Request For Clarifications:

Georgia Tech Grad Office and Lobby Renovation – 7/14/21 Issued for Construction Drawings

RFI 2a – Photo 1:

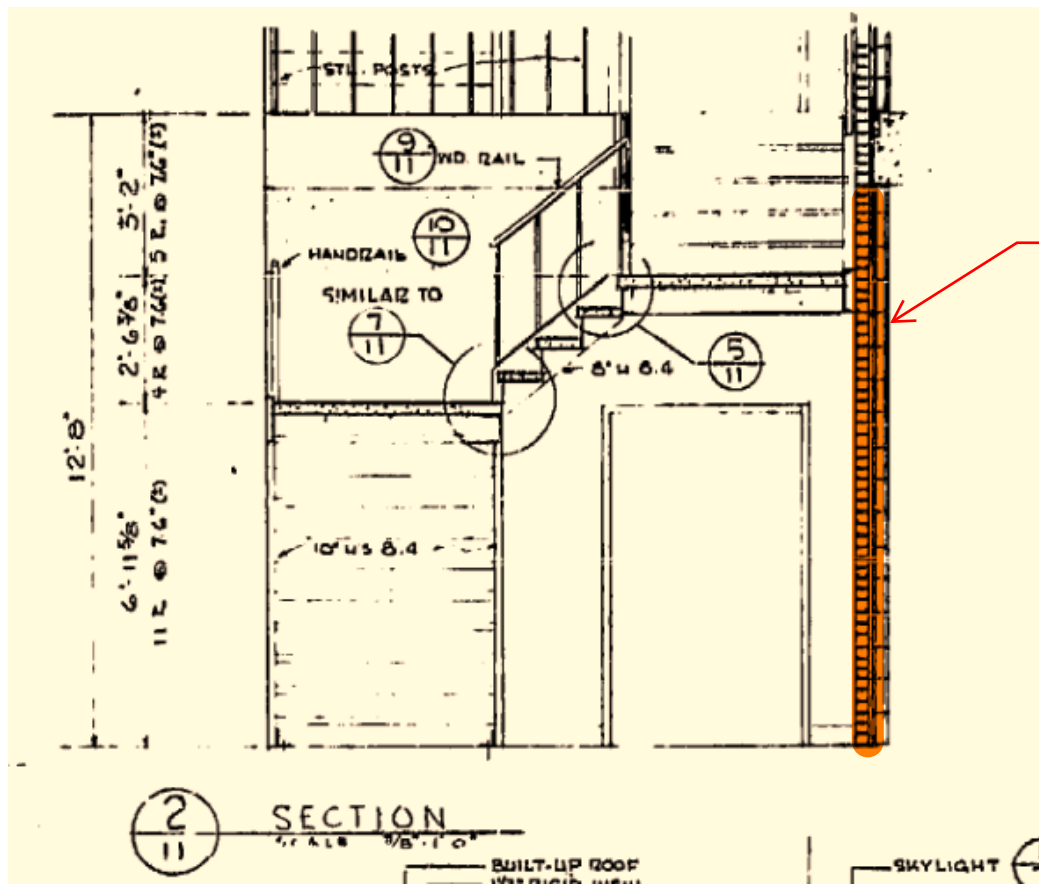
- a. Detail 1/A.021 show the wall between the Stair (B010) and Lobby (A001) to be demolished. Based on the structural report, the brick wall below the second-floor landing is not load bearing, however, it will need to be supported if the wall below is demoed. Please advise on how the brick (Photo 1 - shaded yellow) above and beside the second-floor landing are to be supported before the brick wall (Photo 2 - shaded red) is demolished per plans. Please see the below photo for your reference.
- b. There is currently no detail or elevation drawing that shows us the finish details of the new lobby opening walls once the existing walls are demoed. Please provide a detail or drawing that notes the finishes and design intent required.

REFER TO NOTES ON PROVIDED IMAGES AND NEW ATTACHMENTS.

1. Demo existing cmu and brick wall to the underside of the existing 2nd level framed floor.
2. Contractor to field verify existing brick relief angle at 2nd floor concrete slab per SKS-1. Otherwise provide steel lintel per SKS-2. Contact engineer with any discrepancies prior to demolition.
3. Contractor is responsible for all shoring until all structure is verified or in place.
